**GENOA CHARTER TOWNSHIP
PLANNING COMMISSION
PUBLIC HEARING
JULY 11, 2022
6:30 P.M.
AGENDA**

Attention:	Kelly Van Marter, AICP Planning Director and Assistant Township Manager
Subject:	St. Joseph Mercy Health System – PUD Amendment and Site Plan Review #3
Location:	7575 Grand River Avenue – north side of Grand River, west of Bendix Road
Zoning:	NRPUD Non-Residential Planned Unit Development

**Re: St. Joseph Mercy Hospital
Site Plan Review No. 3**

SEALS AND SIGNATURES

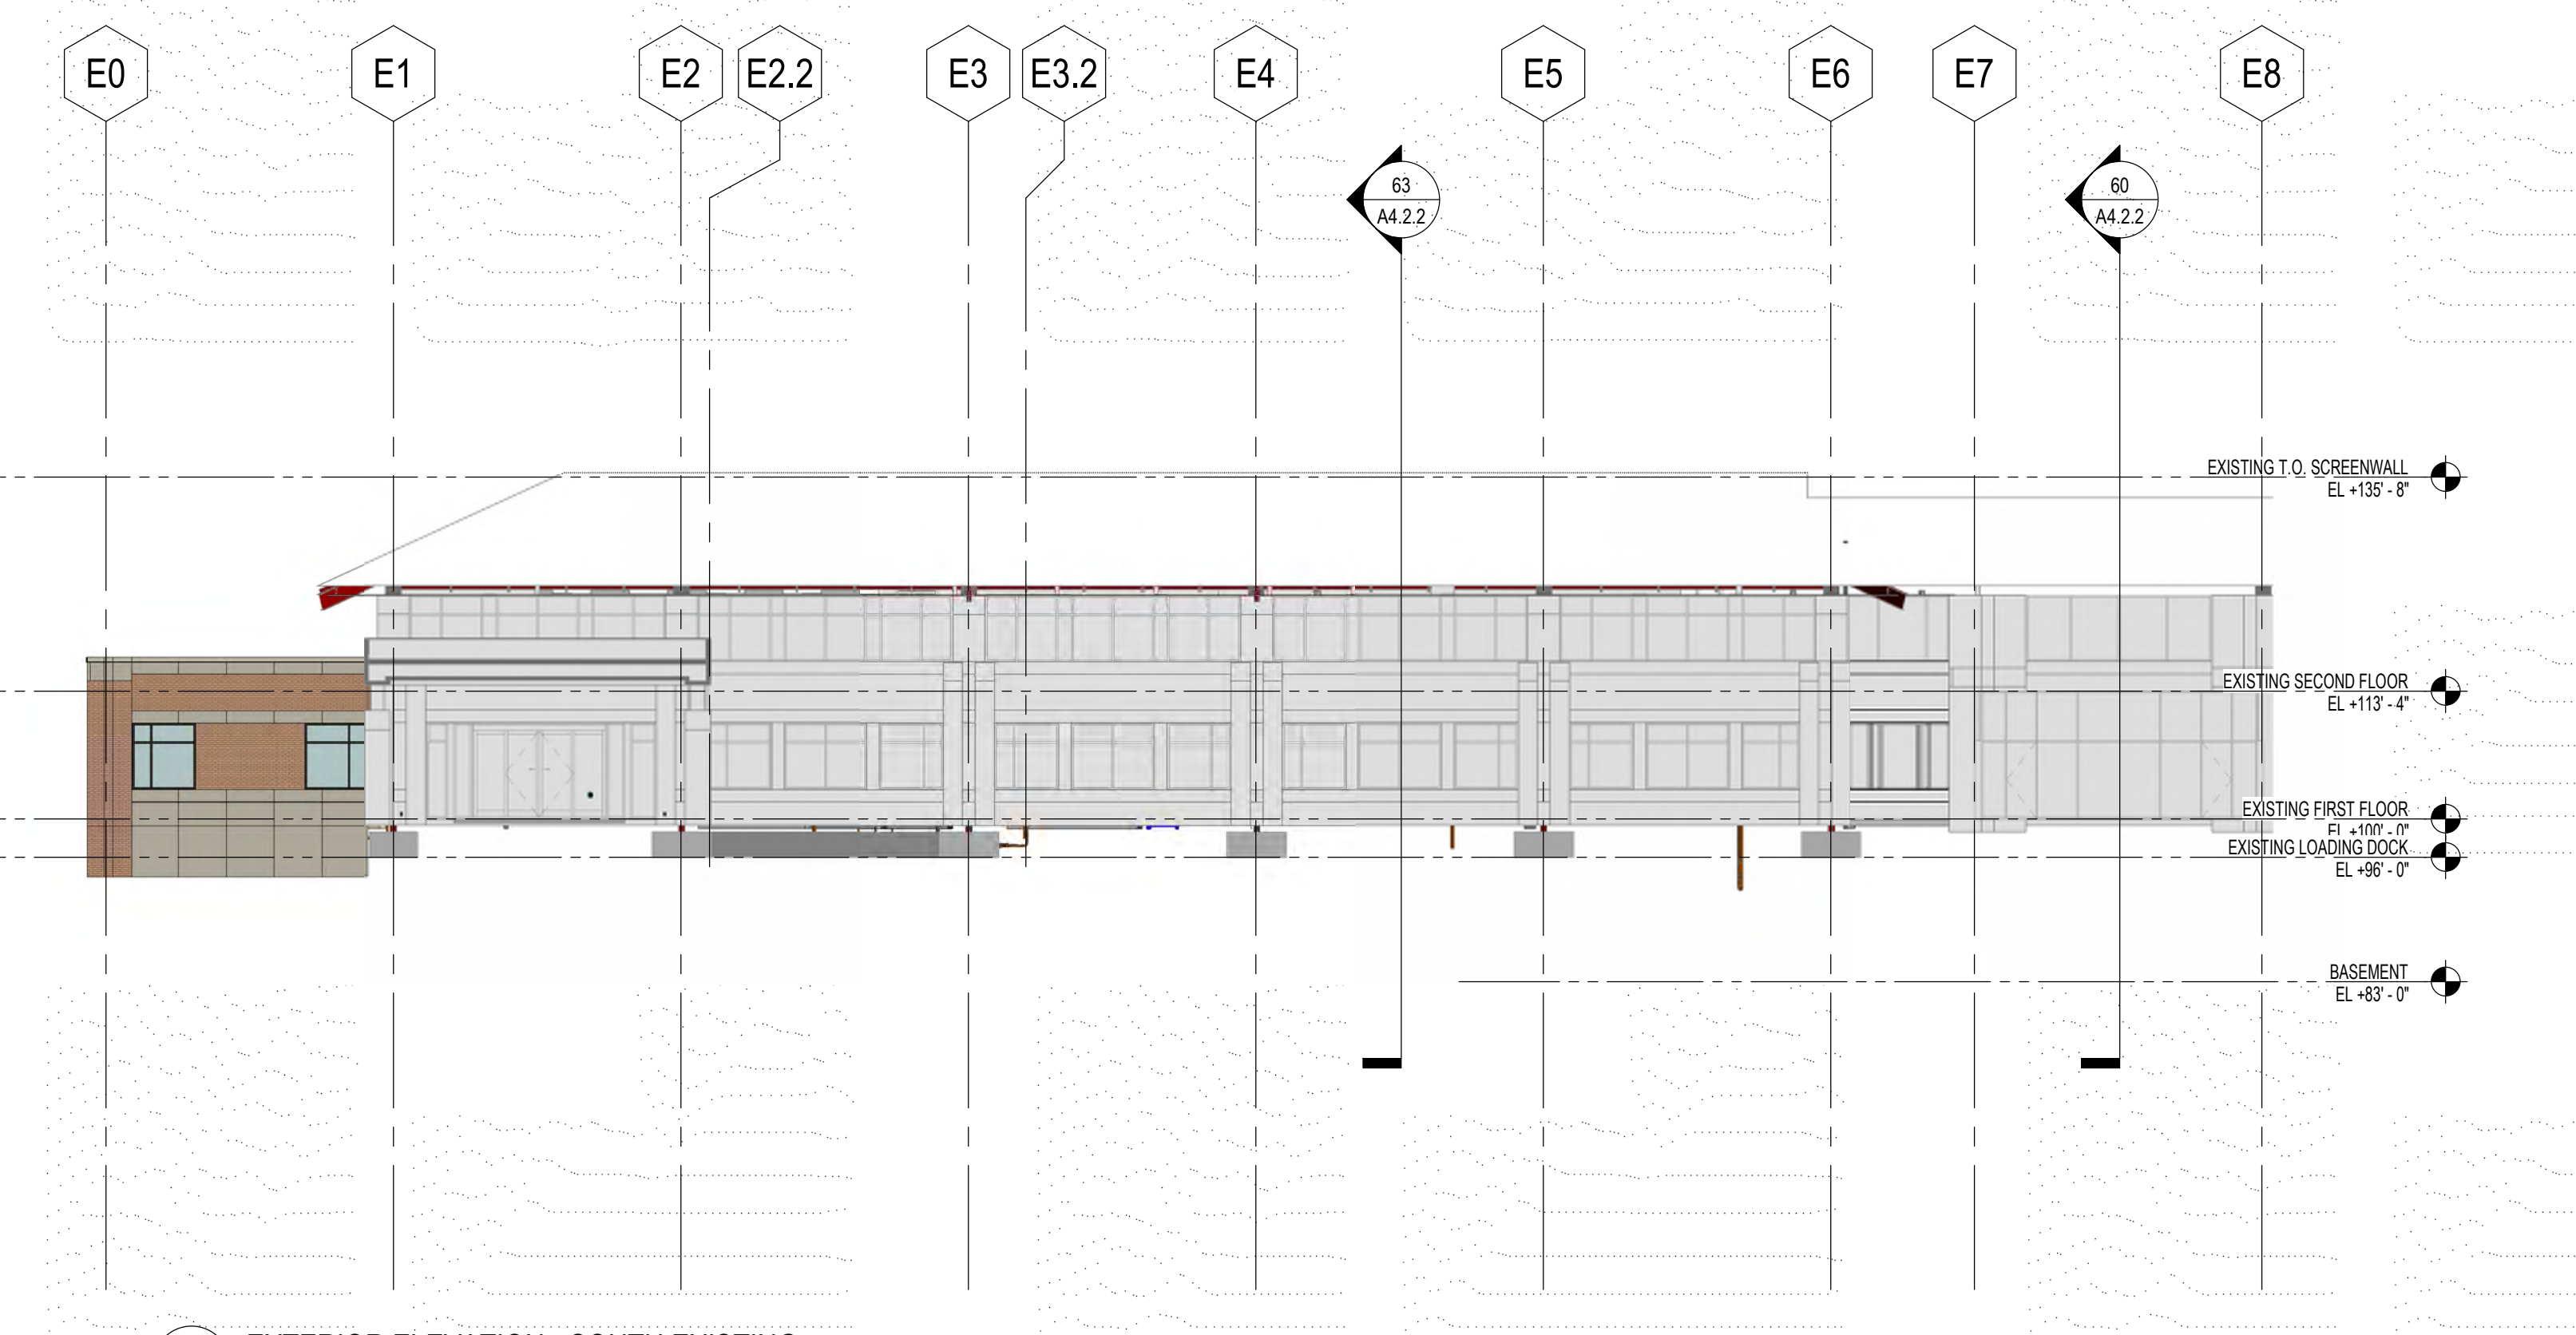
The notes on Sheet A4.1.1 reference Sheet A0.X for the material codes, though this sheet has yet to be provided to our office as part of this review. This document must be provided to the Township for their files.

Building materials and design are subject to review by the Planning Commission, and the applicant should be prepared to present material and color samples at the upcoming meeting.

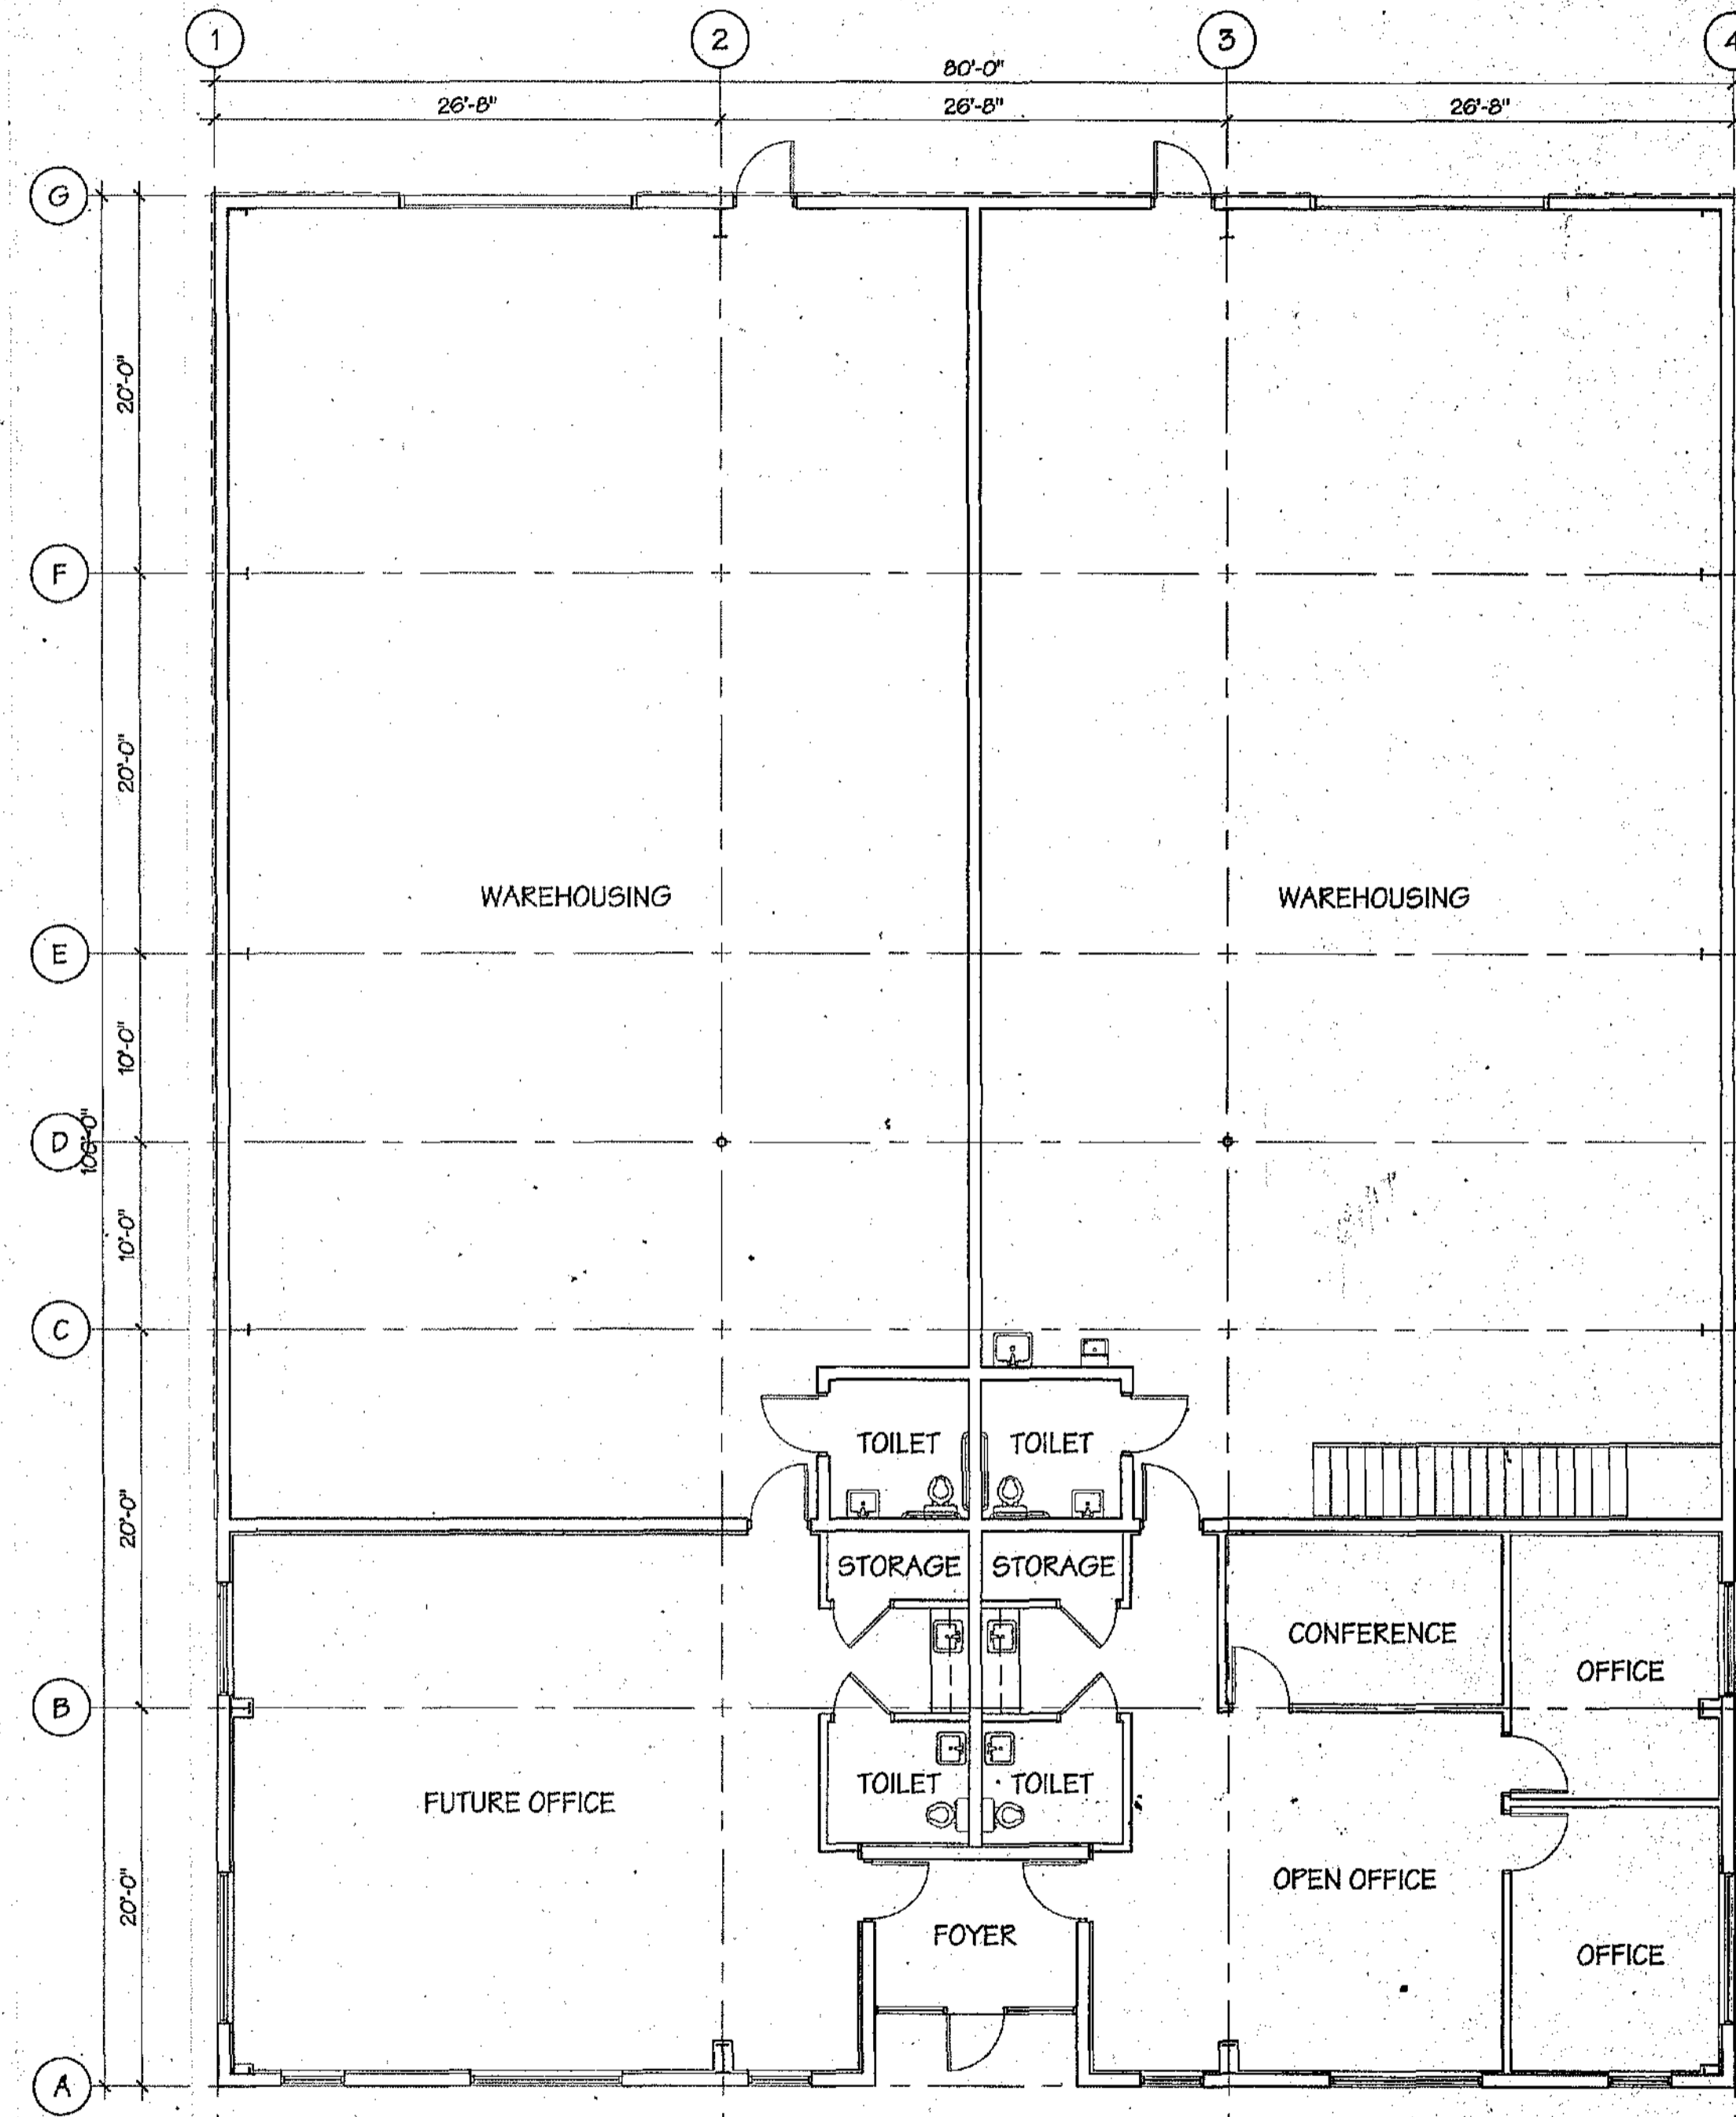
8. The location of a Knox Box shall be indicated on future submittals. The Knox box shall be located adjacent to the main entrance of the structure, in a location coordinated with the fire authority. **(A knox box is located on the East side of the building and is indicated on drawing Sheet 3.)**
